South Carolina Building Codes Council

2021 MODIFICATION INDEX

BCC Modification Index 02/2022

FIGURE R307.1 MINIMUM FIXTURE CLEARANCES

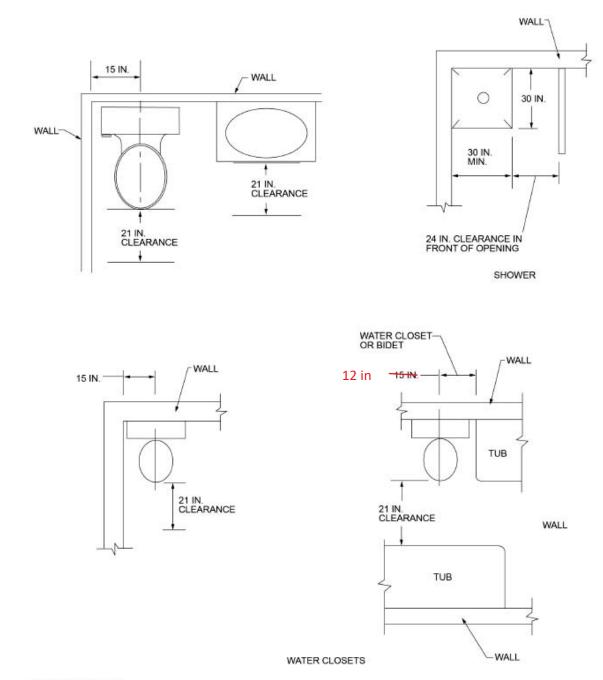
Code Section: Figure R307.1 Minimum Fixture Clearances

Change the minimum dimension for the side clearance between bathtub and water closet or bidet from 15 inches to 12 inches. See Figure on next page.
